February 11, 2011

**Re: DP-3 and DP-4 Well Depletion Locations for Deerwood Service Company Case No. 05CW23; D&A Job No. CG-0430.001.00**

This letter report summarizes our scope of work, data review and analysis of groundwater hydrology and geology for depletion locations from water supply wells DP-3 and DP-4 at the Deerwood Park development in Routt County.

**CROSS SECTION A-A'**

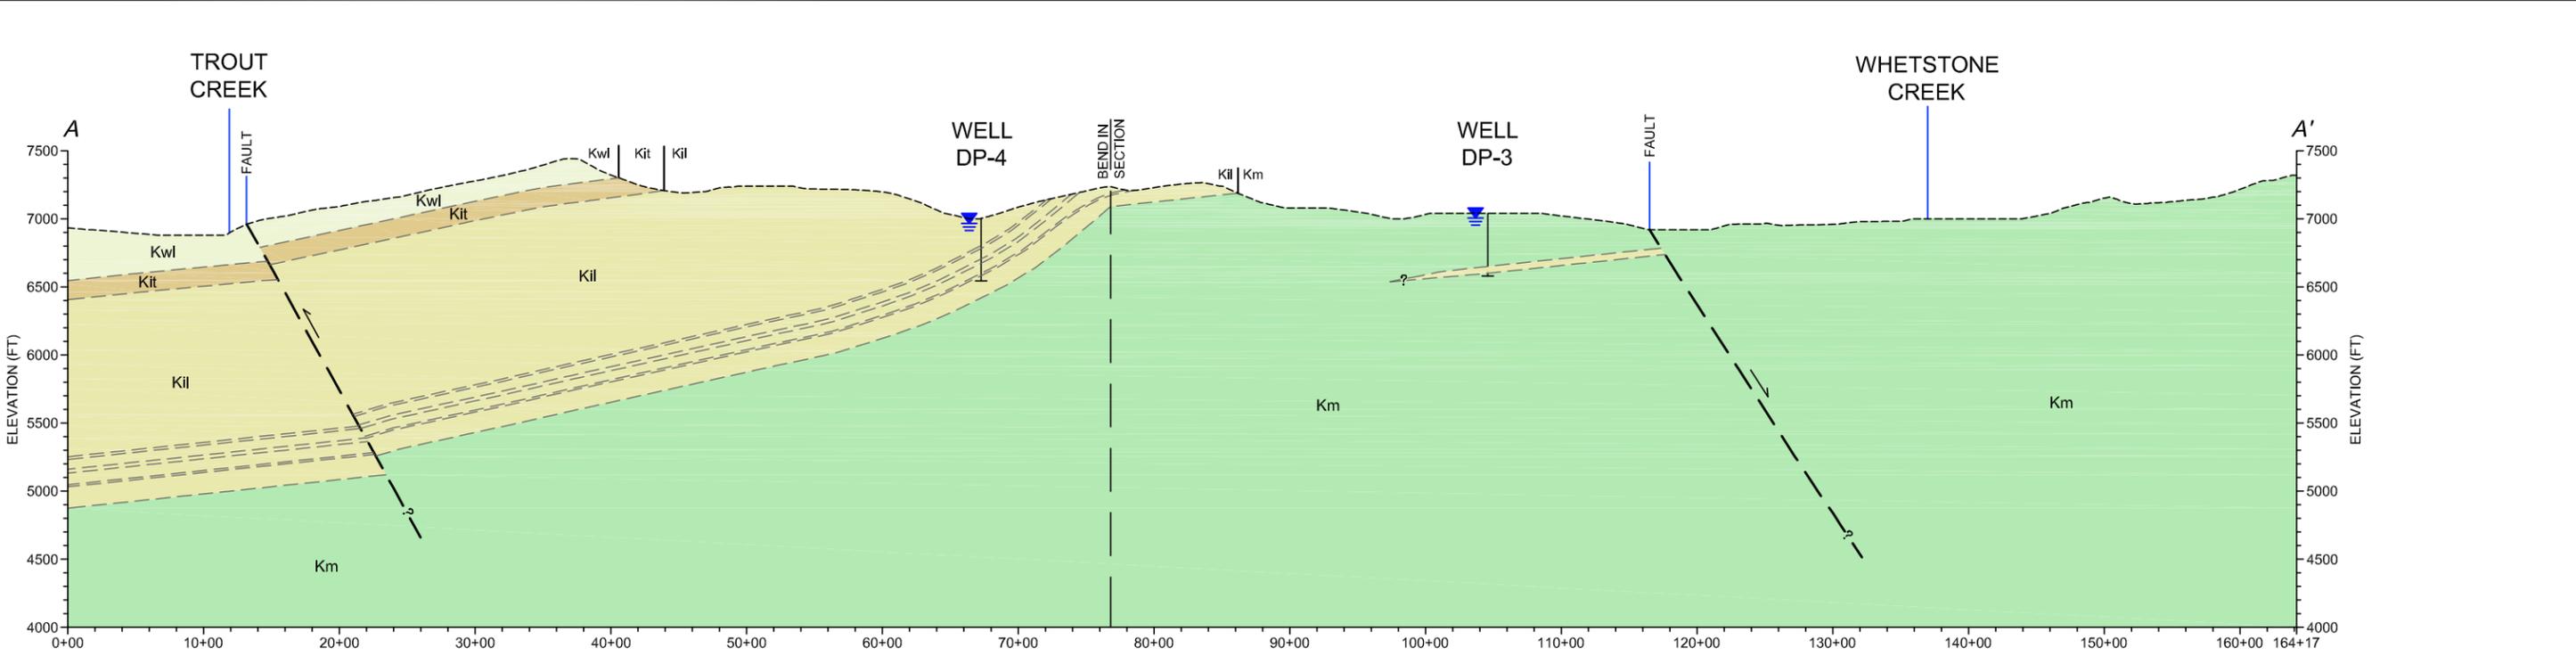
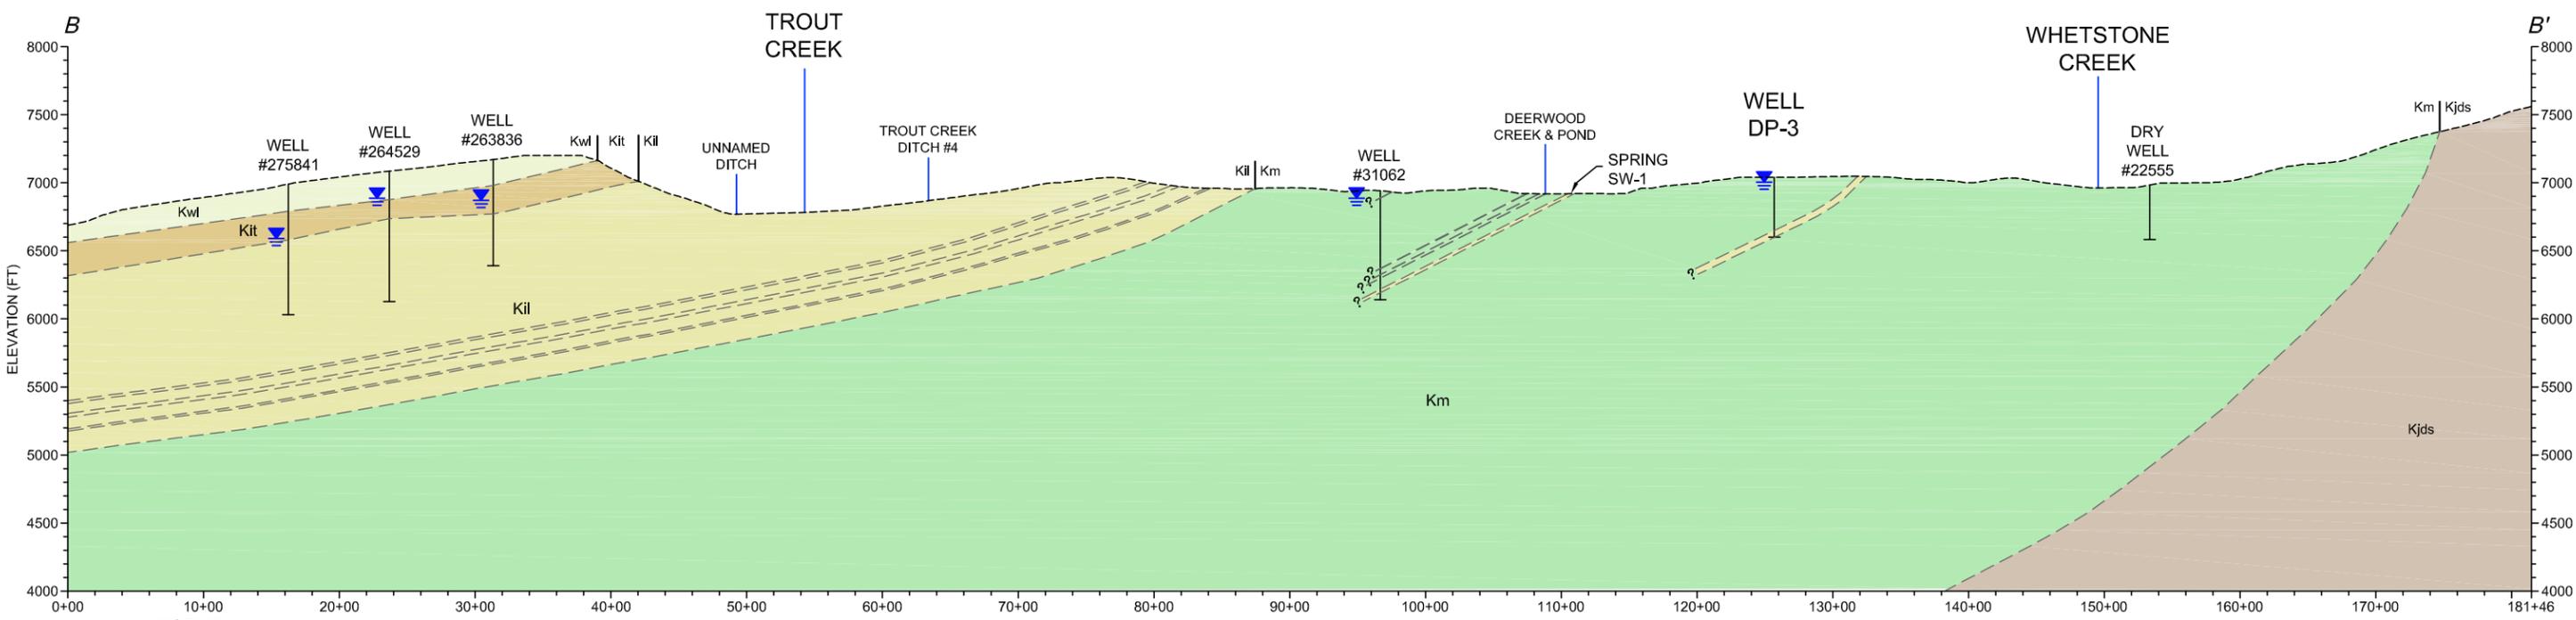
For reasons outlined below, Deere and Ault disagree with the conclusions presented in the 2006 Laramide Stream Depletion Study.

to the fault defining the Whetstone Creek valley and south to Oak Creek. As shown on the geologic map (**Figure 2**) and in the geologic cross-sections (**Figure 3**), the water bearing sandstone beds encountered by the two wells do not intersect the streams or alluvium of Trout Creek or Whetstone Creek. Further, well DP-4 experienced a net drop in total head of 50 feet in the 15 years since it was installed (ABC, 2009). This evidence indicates a strong likelihood that both wells DP-3 and DP-4 are non-tributary wells. However, the beds do intersect the fault defining the Whetstone Creek valley as well as the fault further to the west.

While neither the exact location of the Whetstone valley fault, nor the normal offset on the fault is precisely known, the fault will act as a barrier to groundwater flow across it. Therefore, no hydraulic connection exists between the water-bearing sandstone beds and Whetstone Creek. Depending on the nature and geometry of the fault plane, it is possible that the groundwater in the water-bearing sandstone beds can migrate along the fault plane and be in hydraulic connection with Trout Creek at its intersection with the alluvium, which is at a point approximately 2,540 feet upstream of the confluence between Trout Creek and Whetstone Creek (**Figure 4**). Therefore this is a possible depletion location (location 1) for both wells DP-3 and DP-4. This is supported by the fact that the location where the fault likely subcrops below the Trout Creek alluvium is at an elevation of approximately 6,760 feet and therefore down gradient from both wells DP-3 and DP-4. For well DP-4, this depletion location has a hydraulic length of approximately 8,500 feet and a difference in hydraulic head of 202 feet giving a hydraulic gradient of 0.024 towards Trout Creek. For well DP-3, this depletion location has a hydraulic length of approximately 8,200 feet and a difference in hydraulic head of 247 feet giving a hydraulic gradient of 0.030 towards Trout Creek.

The depletion study performed by Laramide in 2006 has several flaws. The most significant problem is the way Laramide used the Glover method within a confined bedrock aquifer hydrogeologic environment. Laramide explicitly states that none of the Glover assumptions apply to the confined nature of the Iles aquifer. Again, the assumptions of the Glover method include the following:

As discussed in the geologic review, the Iles aquifer is not homogeneous or isotropic because it contains interbedded sandstone and shale; well DP-4 has three separate 20-foot screened intervals and does not penetrate the full thickness of the Iles Formation; and no streambed, Trout Creek or Whetstone Creek, penetrates the full thickness of the aquifer.

The Laramide study does not use the term W because it employs the infinite aquifer solution in the Glover method. The values used by Laramide for the term x are not correct because our geologic analysis shows that the Iles sandstone aquifers are not in direct hydraulic connection to Trout Creek or Whetstone Creek via subcrop due to the faulting and the confining shale layers. To use Laramide's values for the term x, the value of transmissivity would have to be an average value representing all the shale and sandstone beds in the lower Iles Formation between the well and the creek weighted by thickness. Such a value would likely be very small.

The geologic framework presented within this study shows that the hydrogeology of the site is complicated, but can be understood. Because the aquifers in question are confined, it also demonstrates that the hydraulic connection between the wells and the local stream systems is not immediately apparent. Therefore, the possibility that wells DP-3 and DP-4 are non-tributary wells appears likely. However, the geologic framework also allows multiple hypotheses to be formulated for the location of tributary well depletions. In order of decreasing likelihood, the possible well depletion locations, if any occur, are as follows:

- 1) At a point on Trout Creek where the Whetstone valley fault likely subcrops below the Trout Creek alluvium approximately 2,540 feet upstream of the confluence with Whetstone Creek. The hydraulic gradient is approximately 0.024 from well DP-4 towards Trout Creek. The hydraulic gradient is approximately 0.030 from well DP-3 towards Trout Creek.
